TECHNICAL SERVICE BULLETIN

Technical Service Bulletin: 15-1308
Expiration Date: April 30, 2022

TECHNICAL SERVICE BULLETIN 15-1308 REMEDY INSTRUCTIONS

CORDLESS PLEATED SHADES CORRECTIVE ACTION FOR BALANCING SHADE

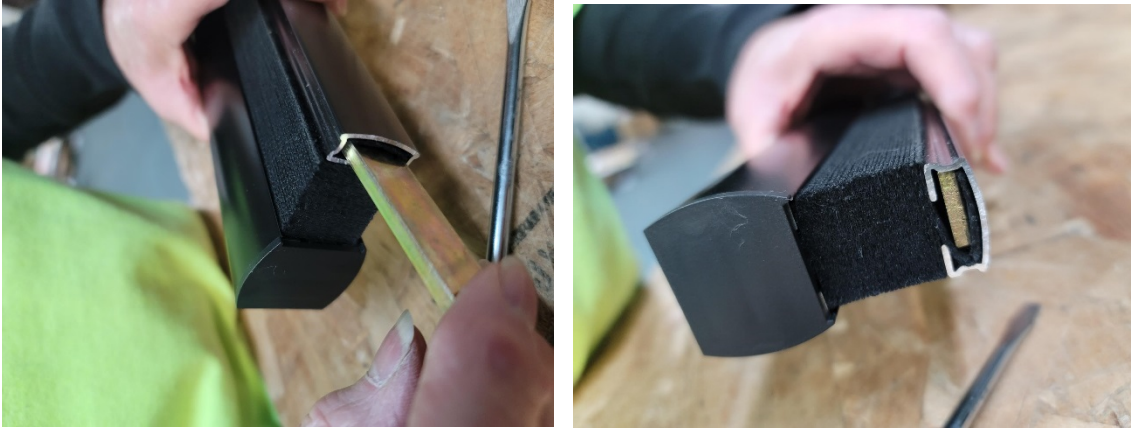
Step 1- Use the flathead screw driver to carefully remove the end cap. The end cap should slide out easily.

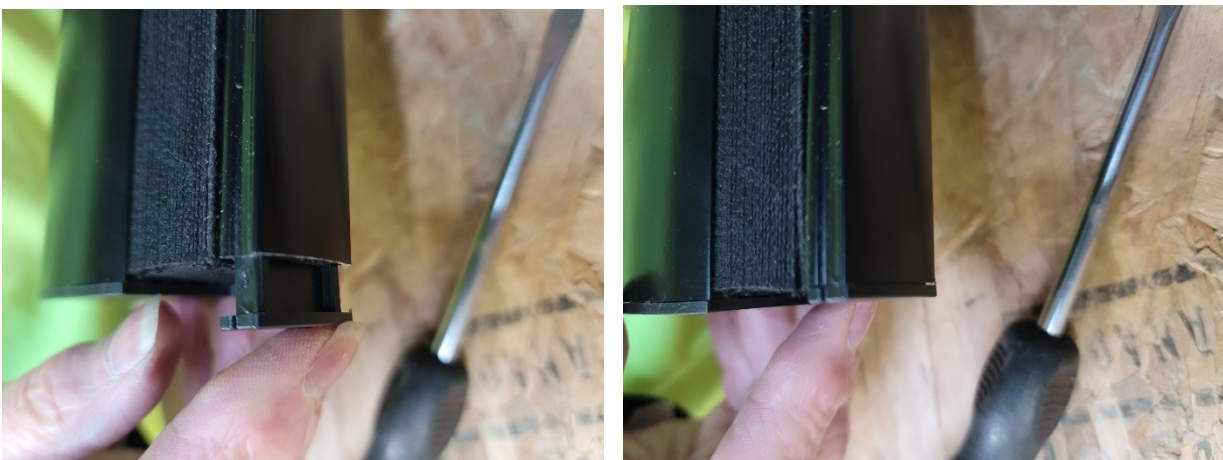
Step 2- Add the weight into the hem bar. Please refer to the chart for additional weight requirements by shade size.

Step 3- Line the end cap up with the headrail and insert it into the rail, pushing it closed. Please note- the curved side of the cap needs to match with the curved side of the rail.
